STATE OF NORTH CAROLINA
DEPARTMENT OF TRANSPORTATION

May 1, 2020

Subject: Revised Modification Request for the Section 404 Individual Permit and Section 401 Water Quality Certification for the proposed Havelock Bypass in Craven County. TIP No. R-1015. Debit \$ 570 from WBS 34360.1.2

PERMIT DRAWING
SHEET 142 OF 165

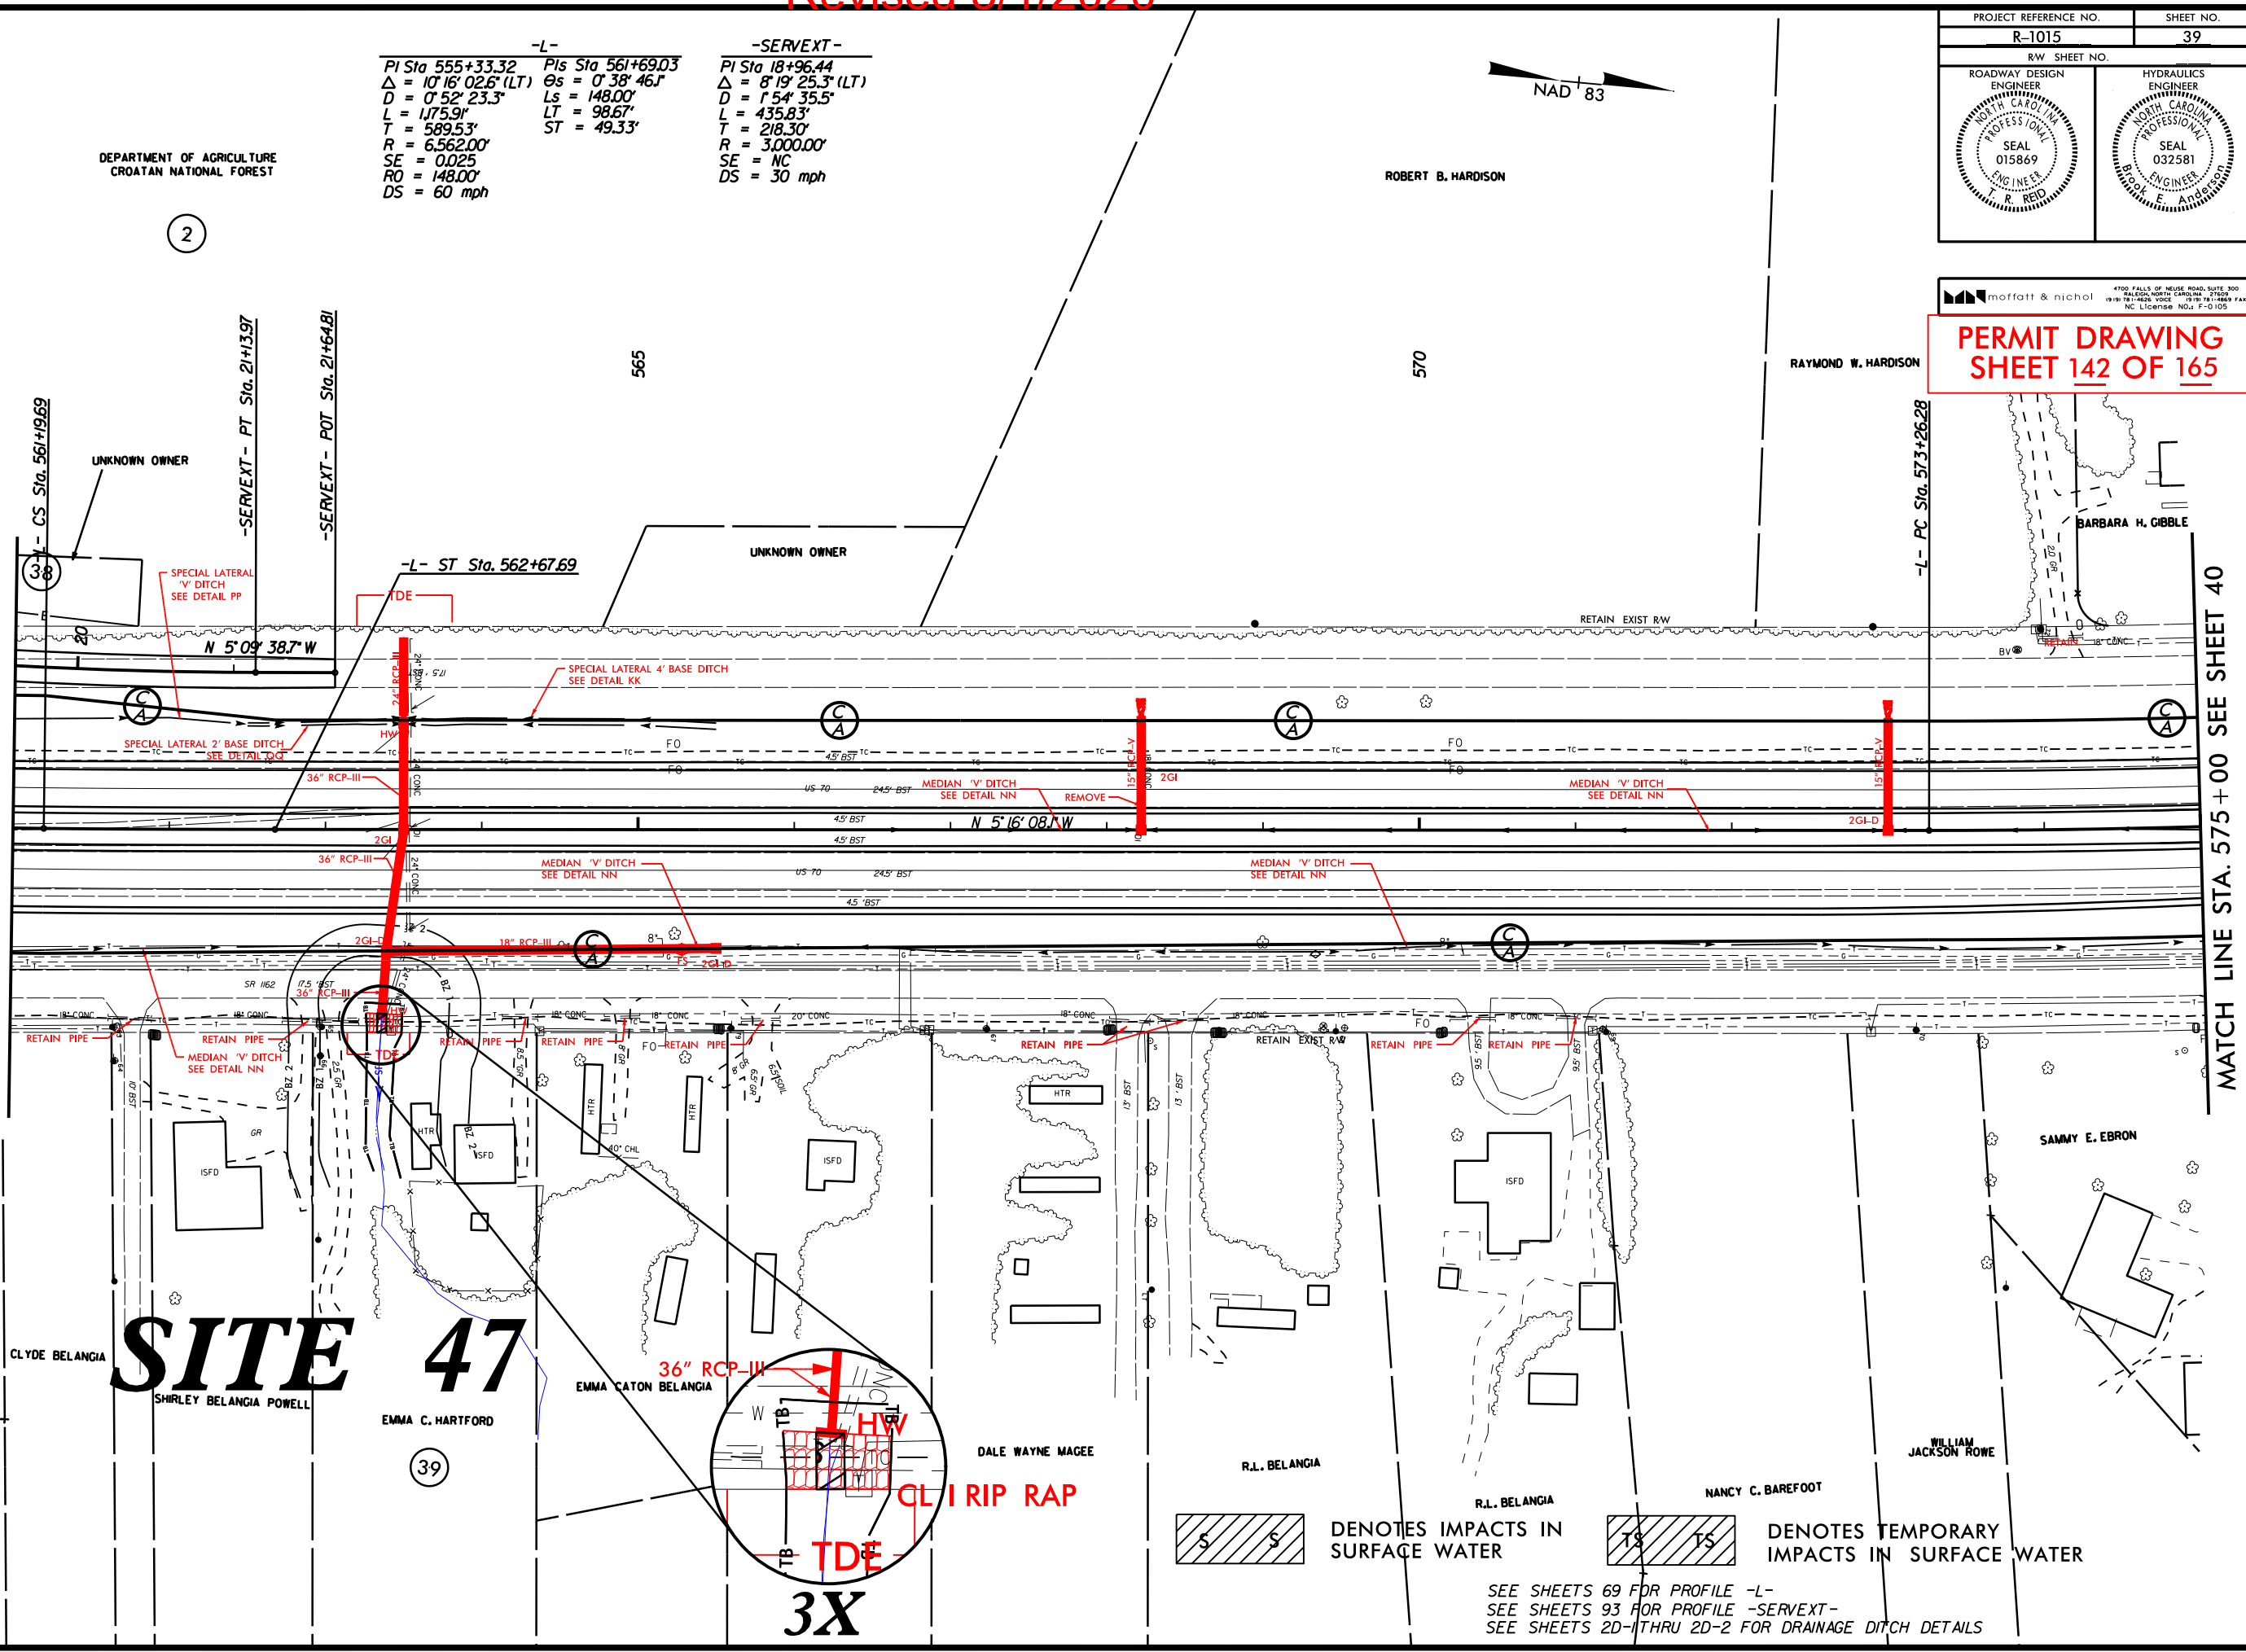
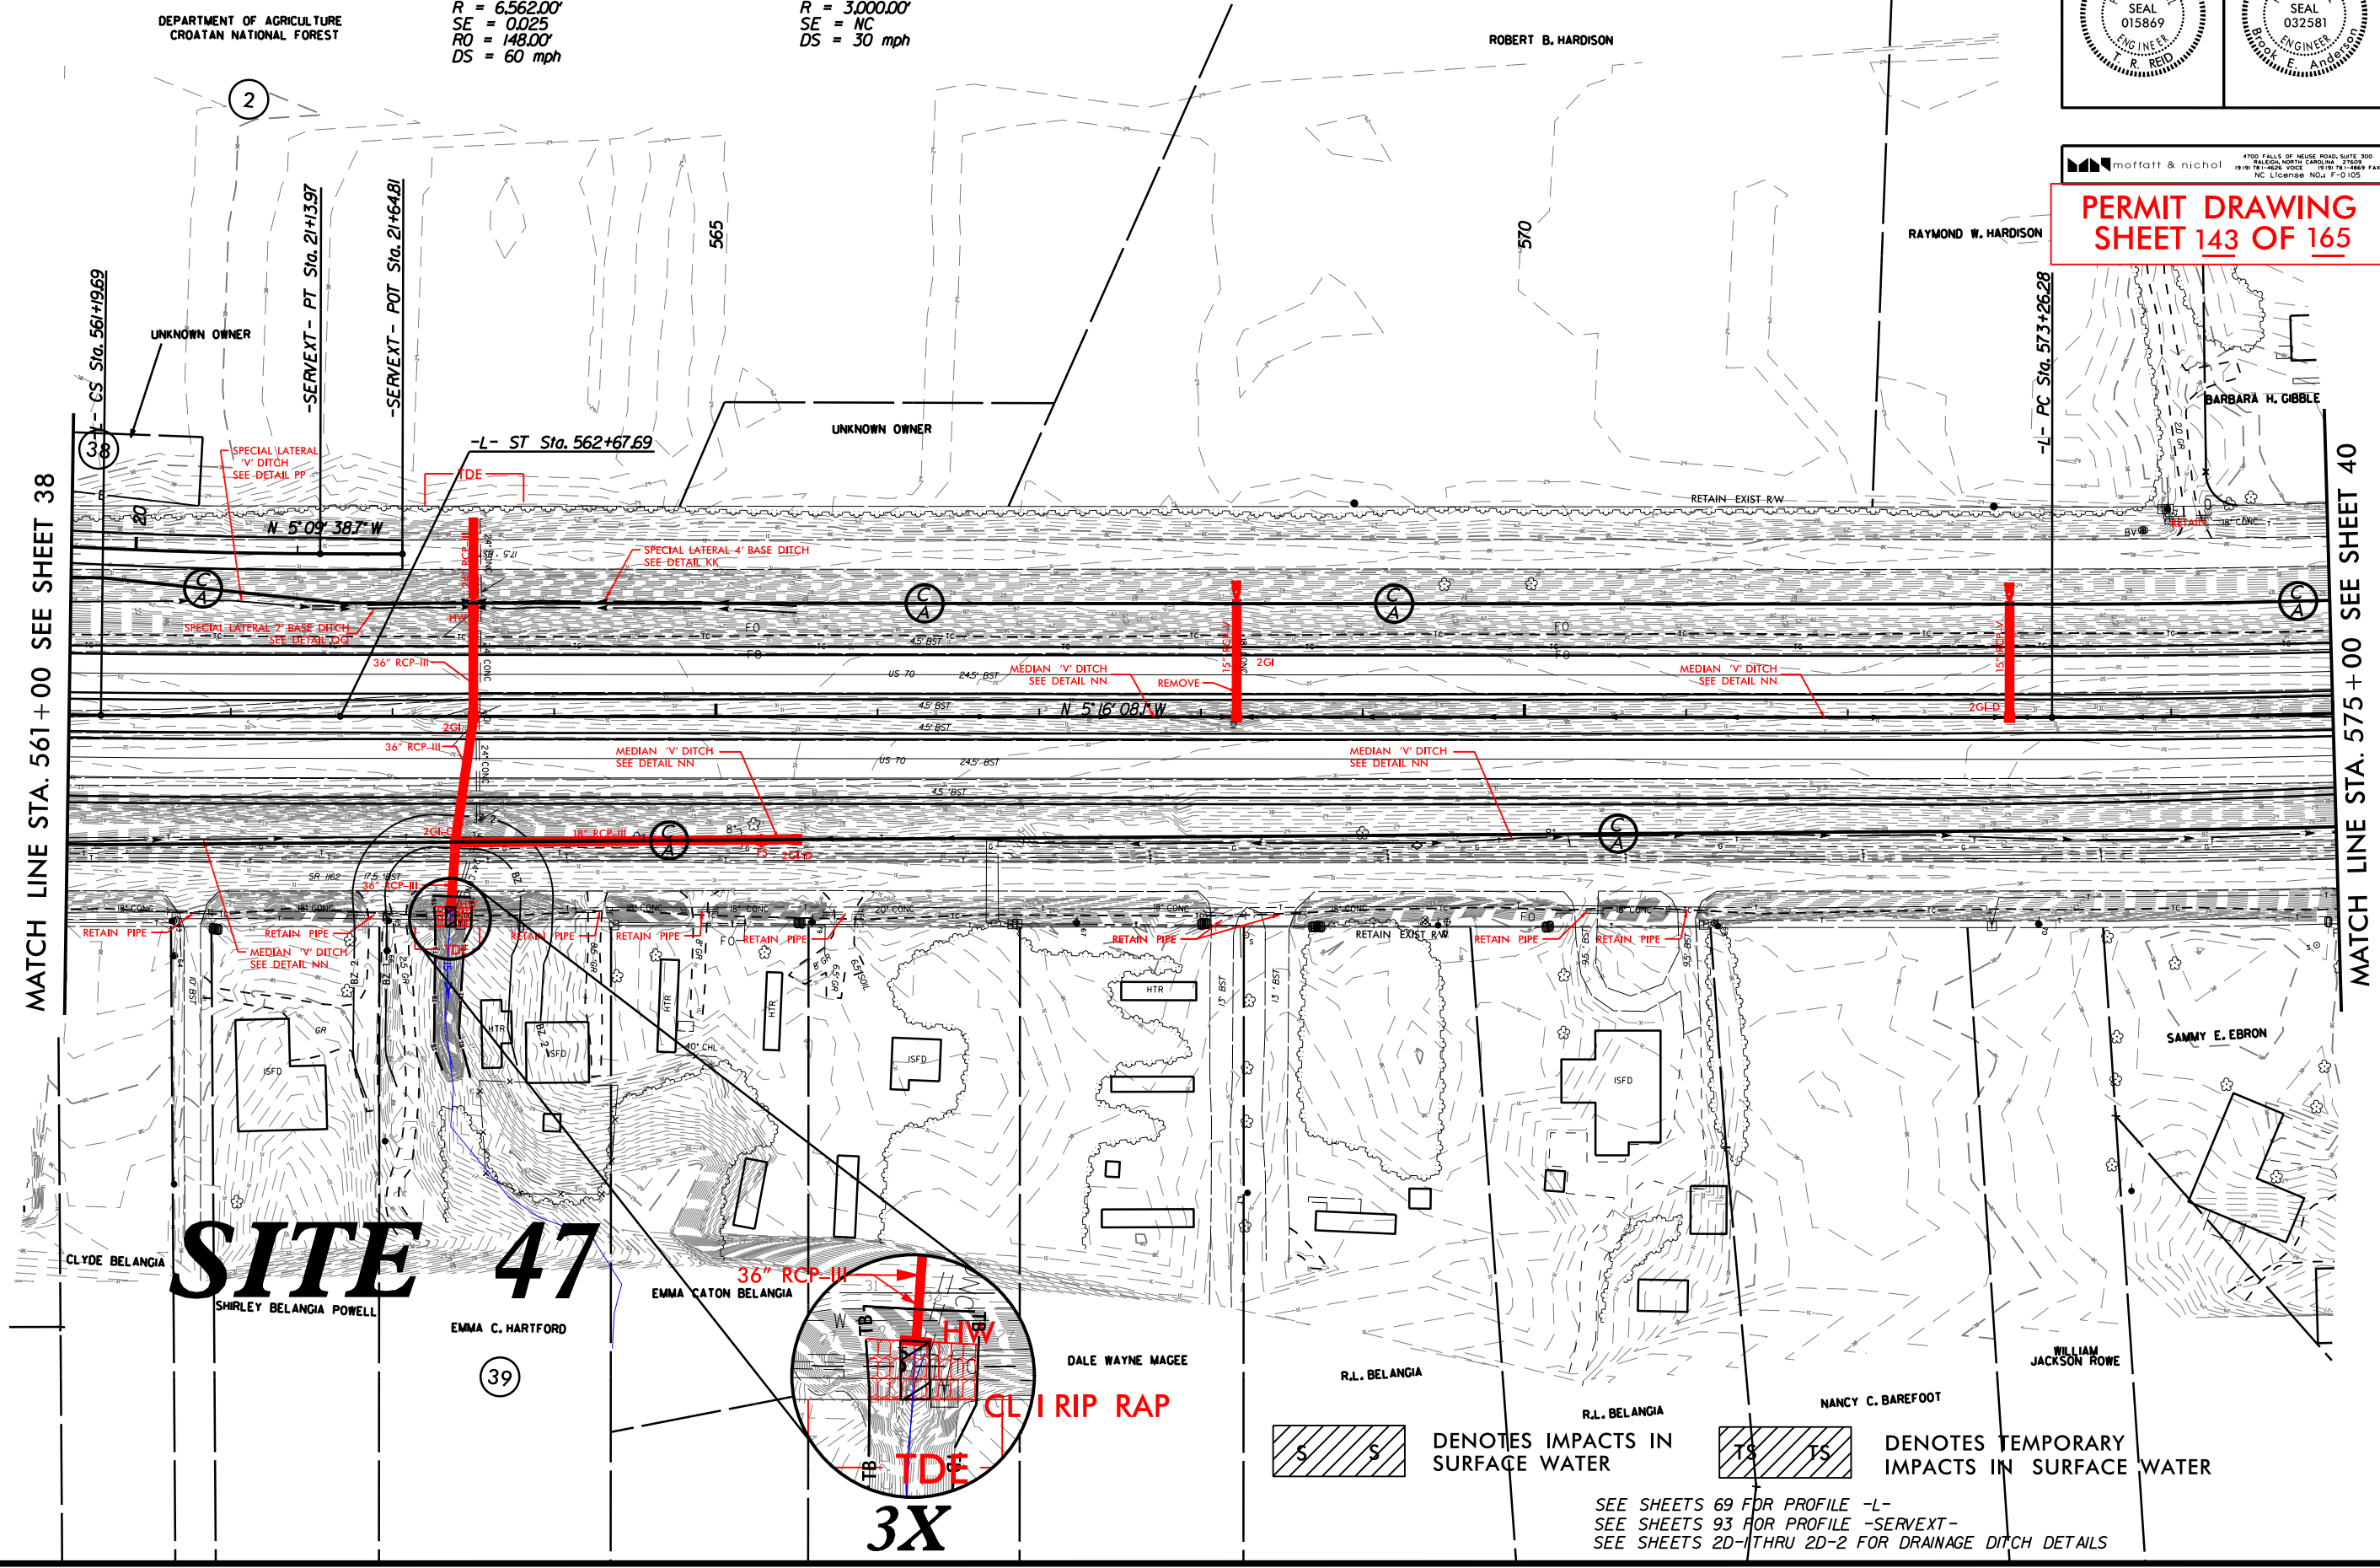
- Fill in Wetlands (new = 2.2231 acre, old 2.2289 acre)
 - Excavation in Wetlands (new = 0.068 acre, old 0.072 acre)
- Site 47, (permit sheets 142 & 143) pipe shortened to eliminate easement on property, HW added. “Temporary Impacts in Surface Water” reduced by 0.01 ac. “Existing Channel Impacts Temp.” reduced by 10’.
